Norfolk Boreas Offshore Wind Farm

Statement of Common Ground

Norfolk County Council

Applicant: Norfolk Boreas Limited
Document reference: ExA.SoCG-19.D9.V3
Deadline 9

Figure 1. Location of Access A, B and D1 on the A47 at Necton

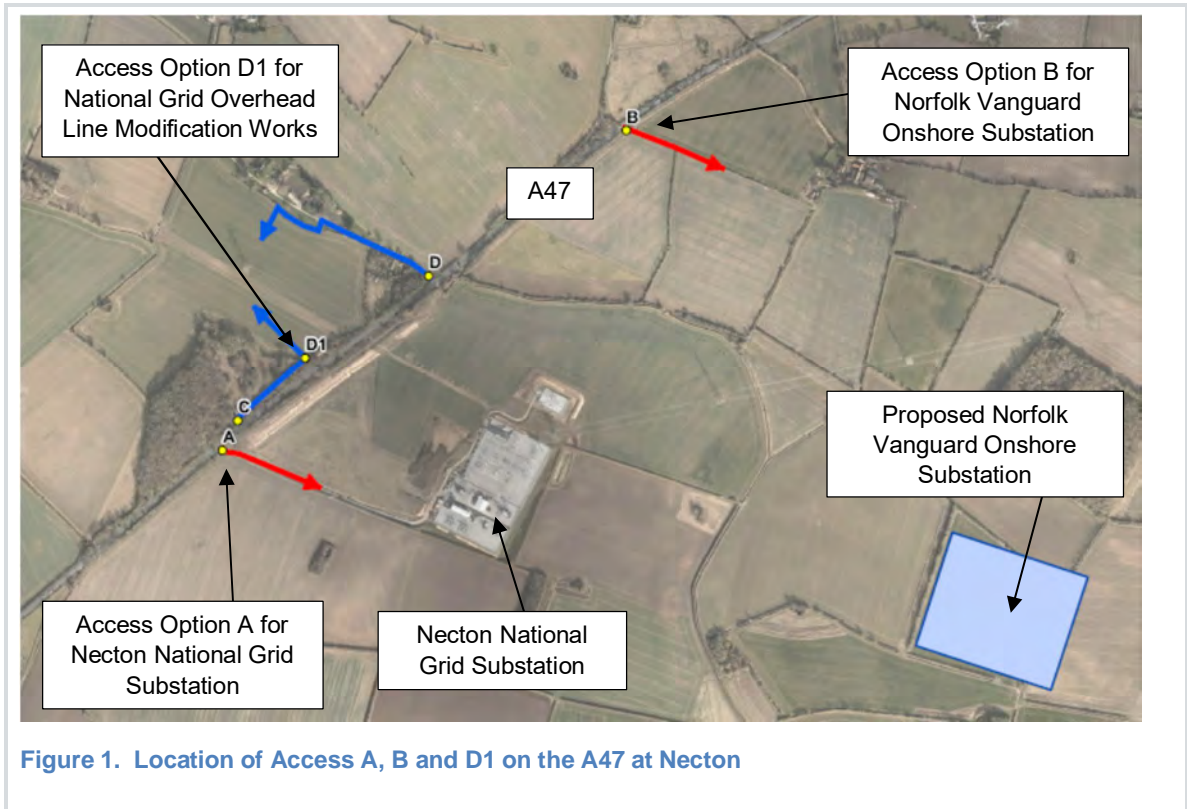
13. On that basis, the layouts currently offered for access points A, B and D1 appear satisfactory, subject to:
- visibility splays being cleared of foliage;
 - visibility being proven in the vertical plane;
 - the implementation of the traffic management measures proposed; and
 - the carrying out of Stage 1 and 2 Road Safety Audits.

15. The updated layouts, traffic management arrangements and traffic flows presented in the SACTN provide sufficient confidence to allow AECOM to advise Highways England that they could now form the basis of an updated Statement of Common Ground indicating Highways England's agreement in principle with the access arrangements proposed.

Figure 1. Location of Cable Crossing sites and proposed access routes

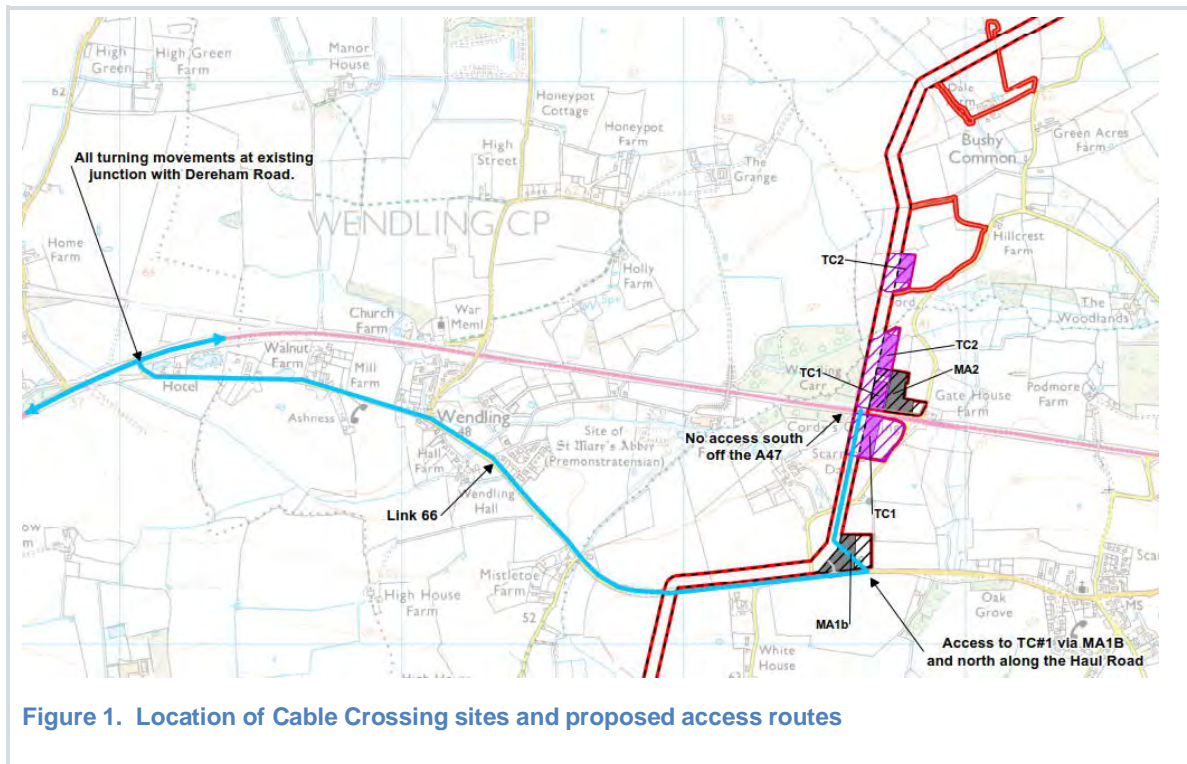
15. The layout of site access junction AC160 illustrated on Drawing PB4476-DR025 D0.1 appears to provide satisfactory geometry to accommodate heavy vehicles turning to and from the A47. There is no suggestion that the use of this junction by vehicles accessing the works would give rise to a queue of stationary traffic within Bushy Common Road waiting to enter the site, such as would risk generating a queue of traffic back to the A47, some 50m away.

17. The visibility splay to the right illustrated for the site access junction appears to provide visibility from an x-distance of 2.4m back into the minor arm all the way to the A47, some 50m away. Whilst this does not strictly comply with the requirements of TD41 Table 2/1, a visibility splay as far as the preceding junction should in practice be adequate to allow the driver of a vehicle emerging from the site access to see a vehicle approaching from the A47 at up to 30 mph. Speeds around the 15m corner radii between the A47 and Bushy Common Road are likely to be less than this. The relaxation of the X distance from 4.5m to 2.4m would be permitted in this location (TD41 para 2.21 refers).

19. The layout of the improved junction between the A47 and Bushy Common Road, illustrated on Drawing PB4476-DR025 D0.1, appears to provide in full for the requirements of DMRB Design Standard TD42 for this type of junction. In addition, the swept path plots shown on Drawings PB4476-DR026 and 027 show that it can accommodate heavy vehicles turning on and off the A47 without clipping kerb lines, and without encroaching on the wrong side of the A47 or the minor road.

21. Whilst the visibility splays have not been proved in the vertical plane, the local topography is generally flat, although there appears to be a slight rise towards the back of the verge on the north side of the A47 to the west of the junction and this should be addressed as the design of the junction progresses. AECOM note that the land behind the highway verge lies within the red line boundary of the development and it is therefore within the power of the Applicant to address any problems.

25. There is no evidence that a Stage 1 Road Safety Audit has been undertaken in respect of these layouts. The CCATN contains an undertaking to carry out both a Stage 1 and a Stage 2 Road Safety Audit and to prepare detailed Traffic and Access Management Plans post consent.
26. On that basis, the layouts currently offered for access to the Cable Crossing work sites at Scarning appear satisfactory, subject to:
- visibility splays being cleared of foliage;
 - visibility being proven in the vertical plane;
 - the implementation of the traffic management measures proposed, including the monitoring of banned right turns; and
 - the carrying out of Stage 1 and 2 Road Safety Audits.

30. The updated layouts, traffic management arrangements and traffic flows presented in the CCATN provide sufficient confidence to allow AECOM to advise Highways England that they could now form the basis of an updated Statement of Common Ground indicating Highways England's agreement in principle to the access arrangements proposed.

Plate 1: Proposed works area

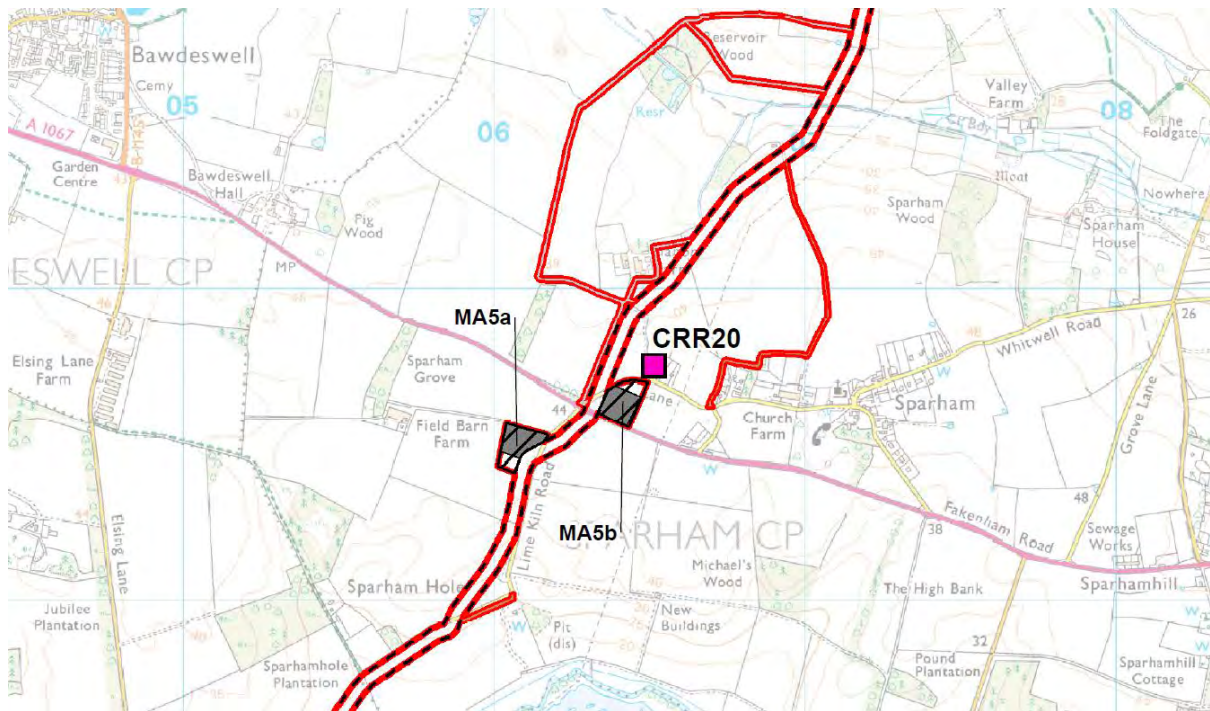
33. The amended construction methodology is a trenchless crossing of the A1067 using Mobilisation Areas 5a and 5b as trenchless crossing drill and reception sites.
